# STAFF REPORT KETCHUM PLANNING AND ZONING COMMISSION REGULAR MEETING OF NOVEMBER 25, 2025

PROJECT: 140 & 180 N Leadville Ave ARCH Workforce Housing Project

APPLICATION TYPES: Design Review (Application File No. P25-033) & Lot

**REQUEST:** Final Design Review and Lot Consolidation Preliminary Plat

C1.01

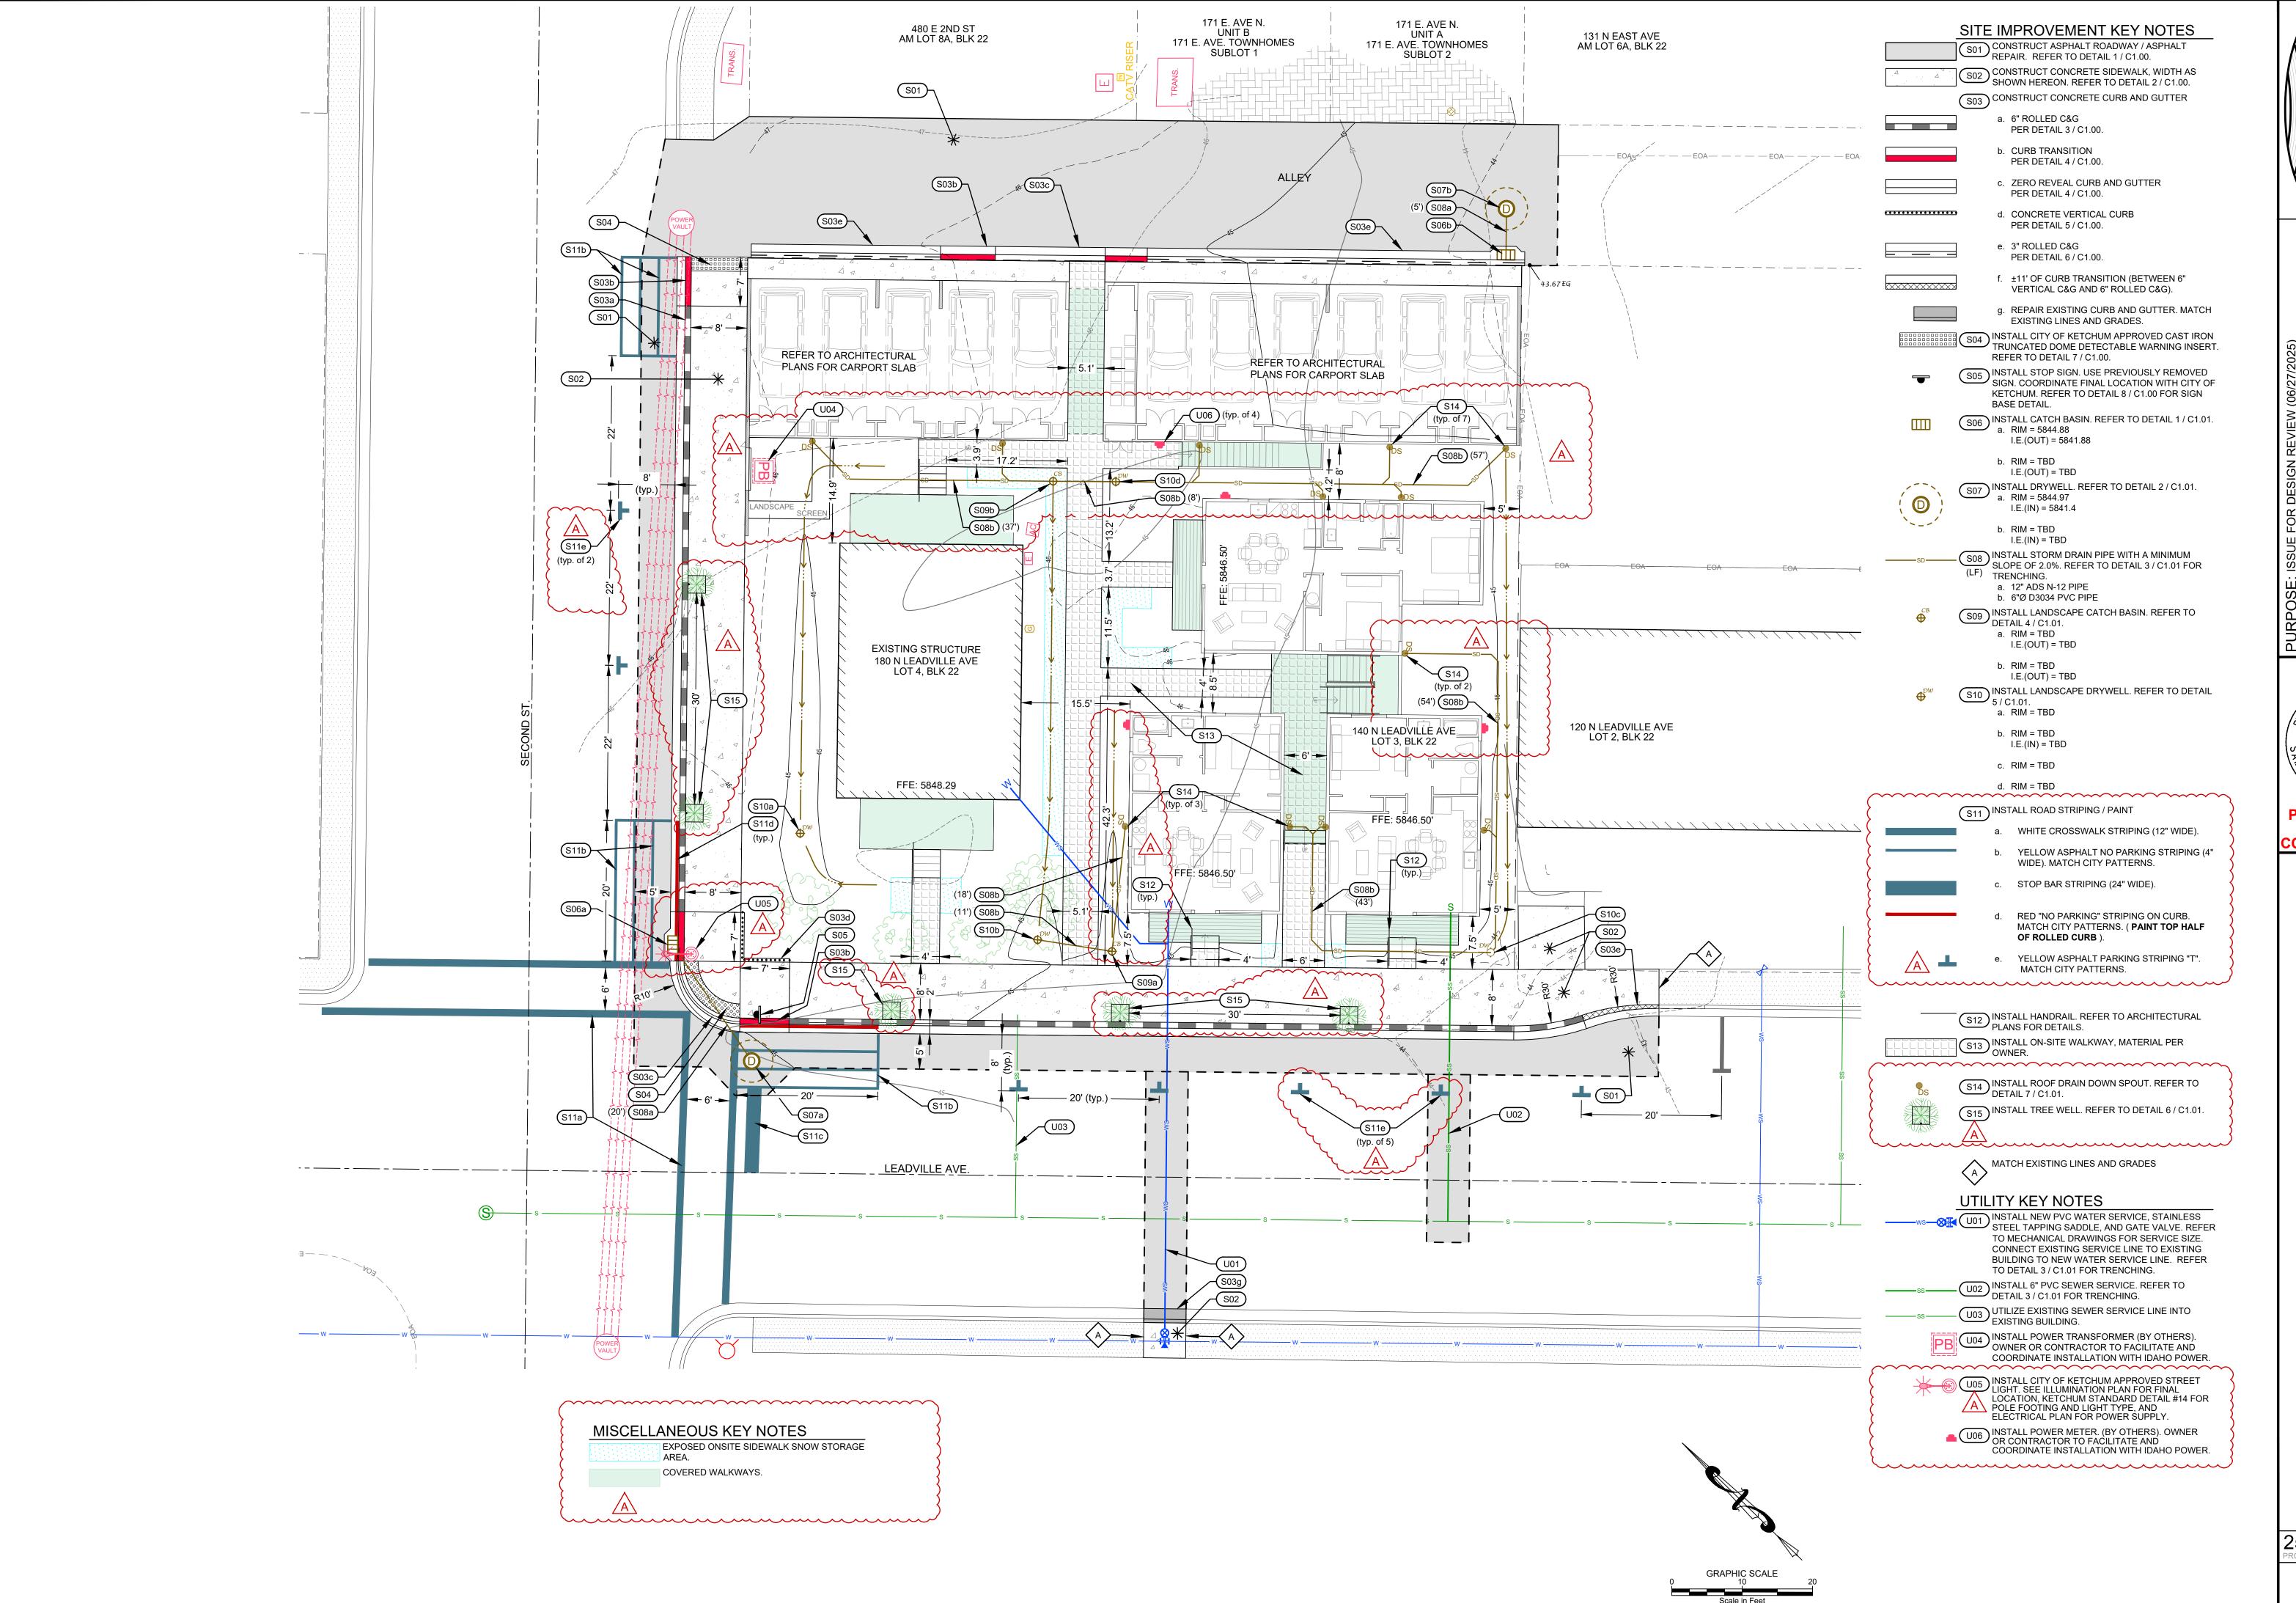
- No Action Required at this Time.
- 3. Comment: Site improvement details are provided on sheets C1.00 and C1.01.
  - Required Action: Please add a note to details 3, 4, 5, 6, and 7 that concrete mix shall be Titan Mix or an approved equal.
